1328-1330 CONGRESS STREET

Your permit application to make alterations to 2nd Floor of professional building, at the above named address, is hereby approved subject to the following conditions:

General construction permit for erection of a two-story masonry building for doctors' offices at the above named location in this city is issued herewith to contractor based on revised plans filed May 18, 1964, but subject to the following conditions:

Check of plans filed with application for permit for construction of a two-story masonry building for doctor's offices at the above named location discloses questions as to compliance with requirements of the Building Code and of other City ordinances as listed below. Before a permit can be issued it is necessary that information indicating compliance be furnished for checking and approval. Details in question are as follows:

1328-1336 Congress

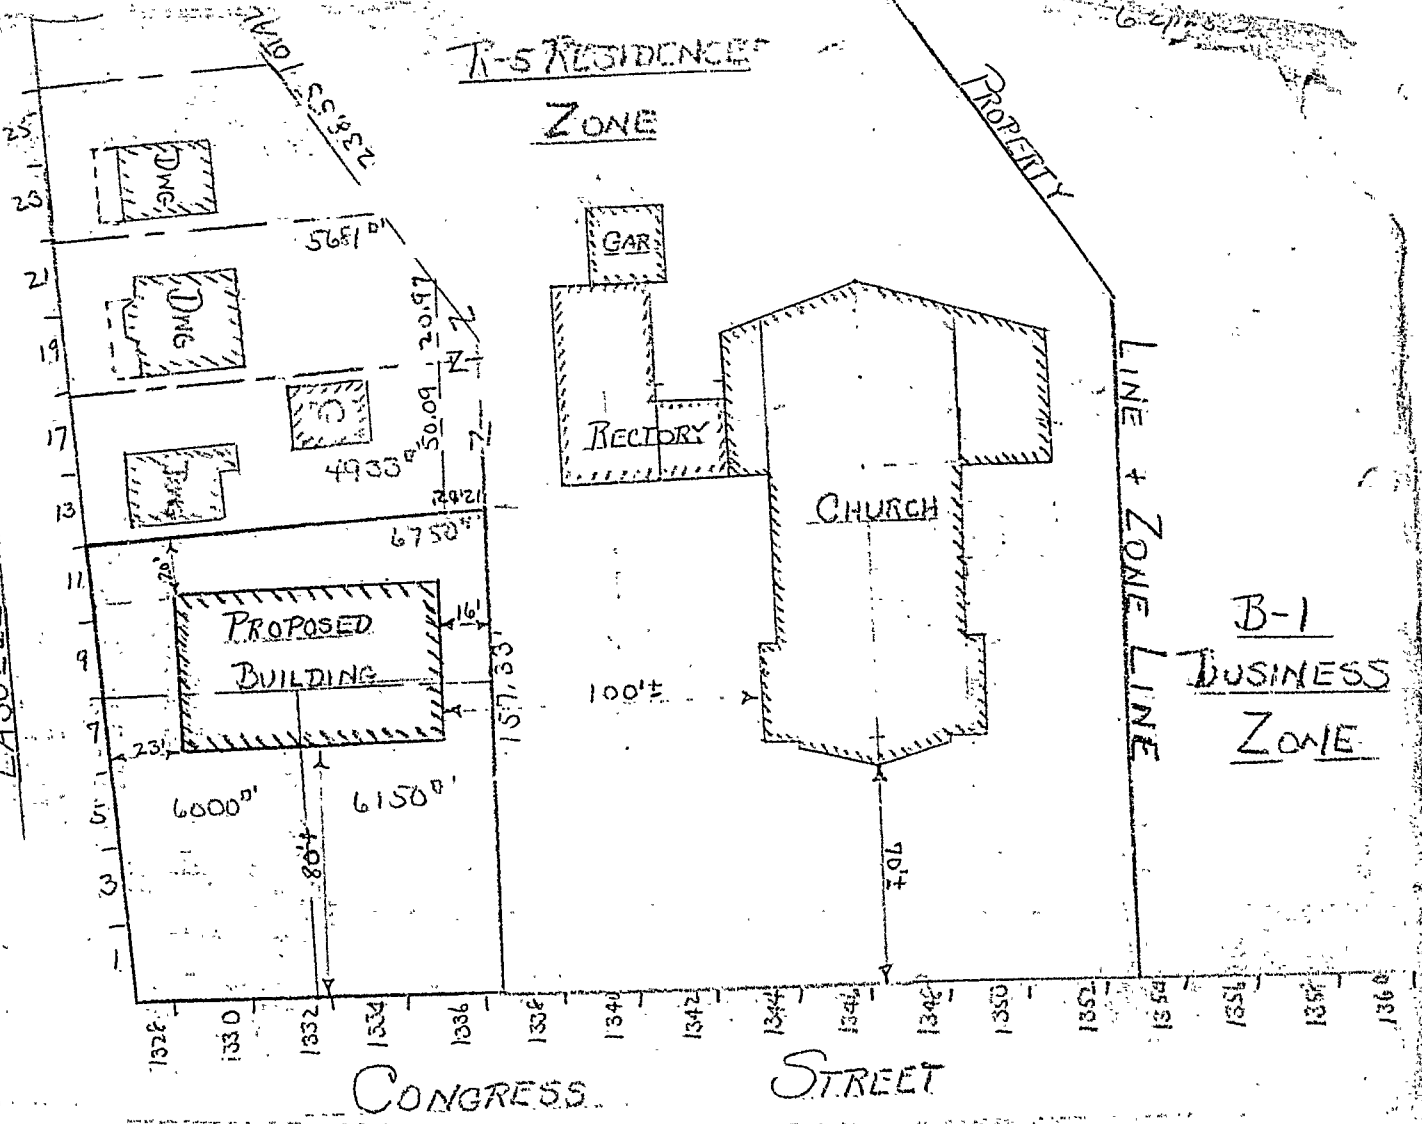
1- Zoning: R-5 Residence Zone, Use allowable as a conditional use under the provisions of Section 6-A-5d.

Sect 6-B-1 - Rear yard - 20' req. - O.K.

Sect 6-B-2 - Side yards - min. 5' and total of 24' req. (23' + 16' - O.K.)

Sect 6-B-3 - Side yard on side street - 15' req. - 23' prov. - O.K.

Sect 6-B-4 - Front yard of 20' req. - 30' provided - O.K.

Sect 6-C - Off-street parking:-

$$\frac{2(48 \times 82) - 3000}{400} = \frac{936}{200} = 4.67 \text{ or } 5 \text{ spaces req.}$$

26 spaces shown
Signs

Location of means of egress serving and story not adequate
